New KSW magnet in 16L1

PSB-MKKSW-EC-0001-00-40

Update after Comments

Figure 9, 3D internal view including the new KSW16L1 magnet, and altered vacuum chambers.

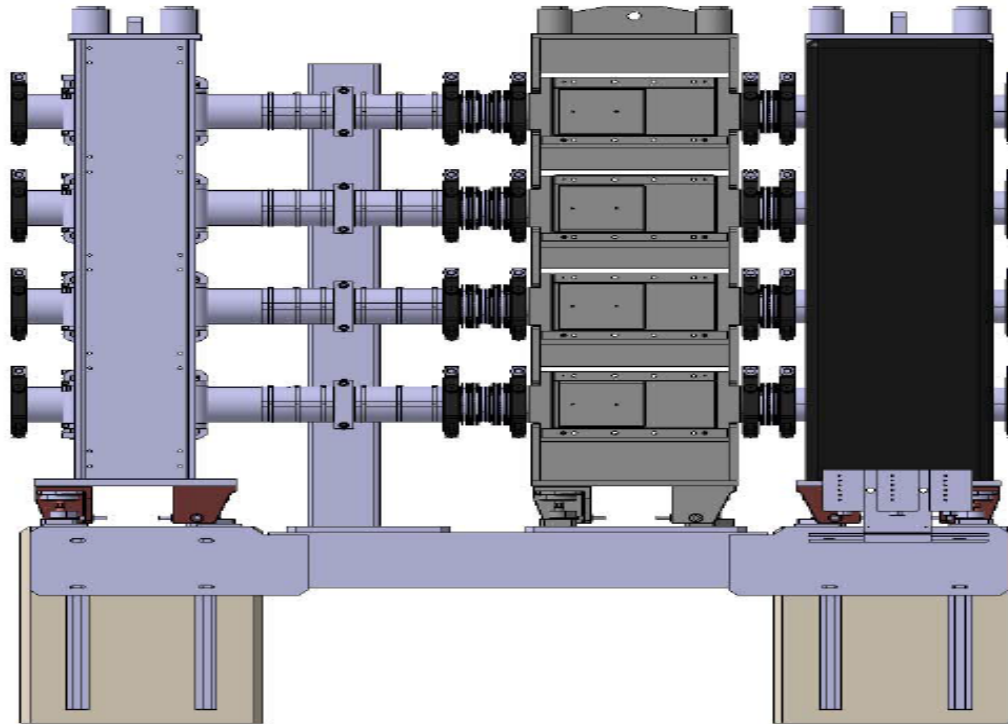
Care has to be taken when considering the installation of the mu-metal around the vacuum chambers. I understand that the equipment drawings for the vacuum chambers are still to be created, but on the integration drawings the mu-metal is obviously too close the corrector magnet apertures.

Care has to be taken when considering the installation of the mu-metal around the vacuum chambers

The new mu-metal shielding has been updated with respect to the comments made by Antony and the old drawing SI.3.40.1096.0 for 16L1 (120.0000000000 shielding to the end of the corrector magnet)

The 3D model for 16L1 and PSBVCDX_0006 has been changed, but drawing PSBLJ_UI0001 still require to be modified by EN/MEF for the next version of this document.

Comment on Antony's remark: manufacturing drawings have been completed according to requirements from TE-VSC, including , modification is required, please contact EN-MME design office asap.
